Tartu Downtown Cultural Centre Architecture Competition

JURY
FINAL
PROTOCOL

30.06.2023

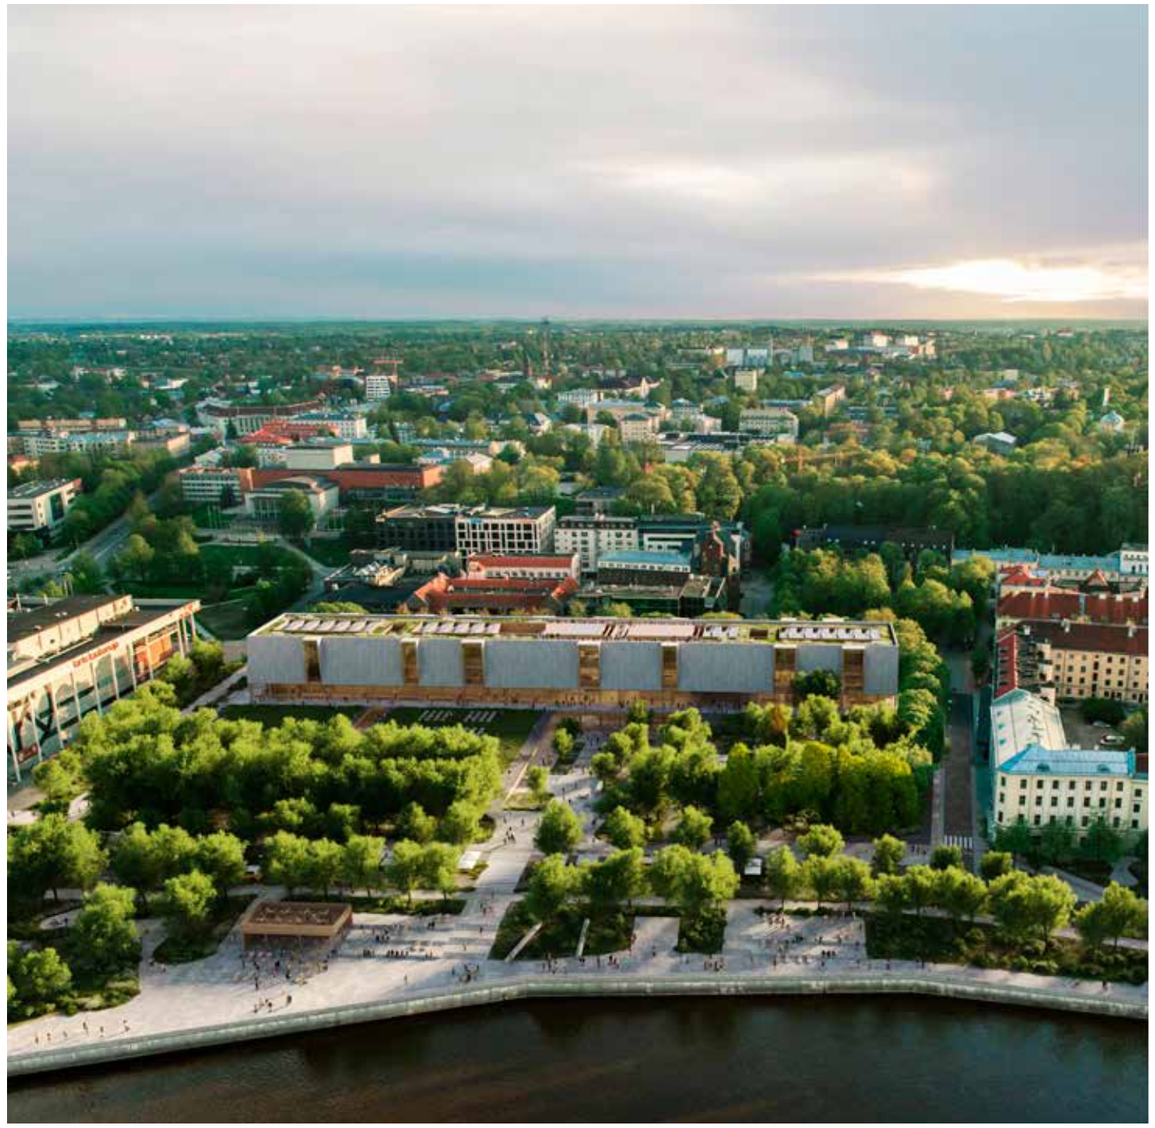
Aesthetically, it is a very strong work that has its own unique architectural charm. The location of the building in the urban space is distinguished from all other competition entries, creating a strong front along Küün street and leaving a complete park area towards the river bank. The celebration of Kauba street in the urban space is elegantly resolved. The building has an exciting dual architectural language, where the first floor is active and well connected to the urban space, while the upper floors have a stronger impact and are calmly rhythmic with windows. The architectural clarity of the building is also one of its biggest weaknesses, as the so-called “enclosed hat” solution creates many dark areas in the interior. Attempts have been made to compensate for this with elegant roof panels, but at the latitude of Estonia, the interior of the building can still appear very dim and crumbling for most of the year. Similarly, a long building is a major barrier in terms of biodiversity, as it completely disrupts the green corridor between Barclay Park and the river, contrary to the competition task, which aimed at strengthening it. Also, the long volume of the building is very difficult in creating internal logistics and synergy of the premises.

+ Clear and strong architectural concept. The layout of the building is boldly different from other entries in the competition.
+ Vabadus street has been changed to be pedestrian-friendly and greener. A connection has been created between Küüni street and Vabaduse street.
+ Many of the current trees will be preserved, and the plan is to plant significantly more trees. The planned green strip in the middle of Vabadus boulevard will improve the ecological coherence of the riverside green area with the Keskpark areas.
+ The sunken cinema square up to the river is a spatially exciting solution, it creates its own environment in the urban space

– Designs and explanations are too general – nothing is specifically written about the contents of the library
– Quite a lot of windowless stone surfaces, the question arises - how to ensure adequate lighting of the interior spaces. The upper massive volume could be much more airy, so that the interior space would also work.
– The connection between Uueturu and Vanemuise streets and the connection with Uueturu park is incomplete. There are no cafes on the riverside.
– Biodiversity has not been dealt with very thoroughly. Meadow and forest landscaping is not mentioned. The various solutions of the herbaceous vegetation and the approach to the park as an ecosystem have not been discussed. There will be more paved areas along Emajõgi than at present.
– The museum is located on the 2nd floor below the utility rooms, there is no synergy between the museum and the library, there is no daylight for the conservators.

– The surfaces of the warehouses are located far from the stages, and it is not possible to push things directly from the warehouse onto the stage, in the small hall there is only one artist’s access to the stage.
– A lift from the ground is planned for the lorry (approx. 28 tons) serving the building, which is not a realistic solution – very expensive
– The gross height of the parking floors is 3 m, which, together with the suspended ceiling and communications, makes the space about 2.2–2.5 m high, which is not enough.
– On Kauba street, from Vabaduse street to the river and in the area of active leisure, the movement paths solved only by stairs are not suitable for people with mobility disabilities.
